# Formula SAE-A Rules Enquiries

## Questions and Answers

### Question about template – RE: 07-2020 – 08/03/2020

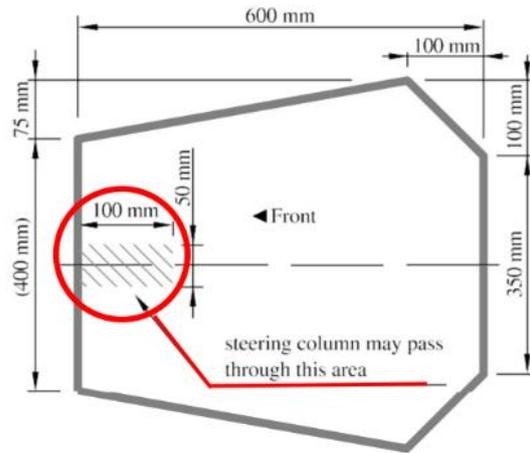
Question: FSAE rules T1.1.1 - cockpit opening template. We are designing our machine for it. On attached picture left one shows Formula SAE Rules 2020. Right one shows local rule of Formula Student Germany 2020. A cockpit template of FSG has steering column pass through area. In Australasia competition. Is it same or not?

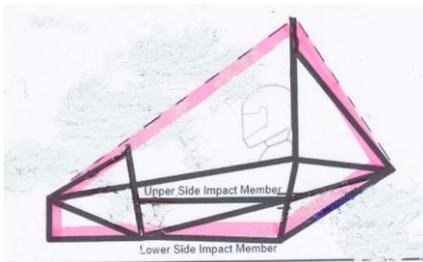
**Question (part1):** *I was planning to mount a bracket on the backside of the main roll hoop bracing that will then attach to the upper side of the rear wing as a mount (swan neck mount). However, I am confused as to what "additional bracing" must be added to the roll hoops to prevent bending loads in the braces in any rollover attitude?*

**Question (part 2):** *The rear wing was designed to have a bracket that is attached to the Main roll hoop bracing and top side of the rear wing. However, I am unsure what is classified as "additional bracing" and if there is any particular requirements that need to be met; such as specific areas where there needs to be additional mounting or specific bracing types.*

**Answer:** To avoid bending loads from anything mounted to the rear braces (such as a wing) from inputting a bending load to them, an additional tube would usually be required at the point where the wing mount attaches to the brace, creating a node which would then attach at the other end to a node on the Primary Structure, thereby creating triangulation and avoiding bending loads.
